City of Portland, Oregon
Bureau of Development Services
Inspection Services - Land Use Services
 FROM CONCEPT TO CONSTRUCTION

NOTICE OF A TYPE II DECISION ON A PROPOSAL IN YOUR NEIGHBORHOOD

CASE FILE NUMBER: LU 15-232118 HR – SOVEREIGN HOTEL RESTORATION

1 PROPOSED SOUTH & WEST ELEVATIONS
1/16" = 1'-0"

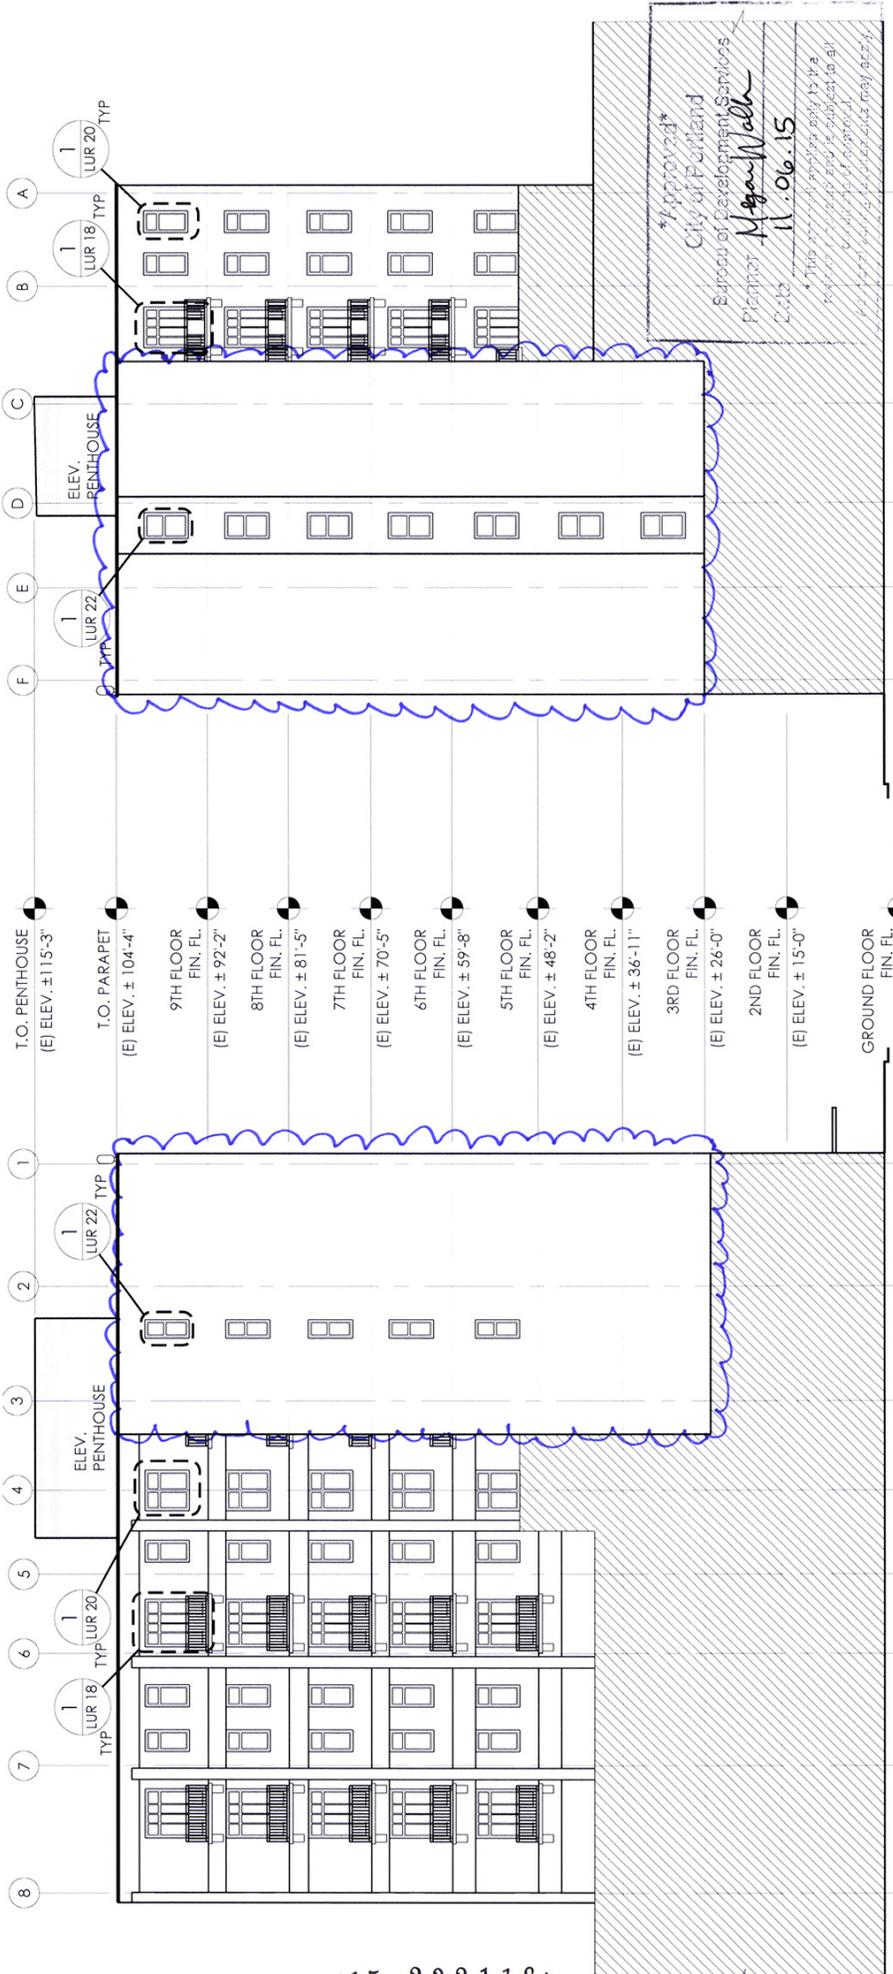
- A. As part of the building permit application submittal, the following development-related condition (B) must be noted on each of the four required site plans or included as a sheet in the numbered set of plans. The sheet on which this information appears must be labeled "ZONING COMPLIANCE PAGE- Case File LU 15-232118 HR." All requirements must be graphically represented on the site plan, landscape, or other required plan and must be labeled "REQUIRED."
- B. The restoration of the two 8-story tall murals is approved with the condition that the proposed restoration matches the existing condition as closely as possible, and color, paint type and outlines are to be maintained; see attached Exhibit C-8.

MURAL RESTORATION APPROVED W/ CONDITION B THAT COLOR, PRINT TYPE + OUTLINES ARE MAINTAINED.
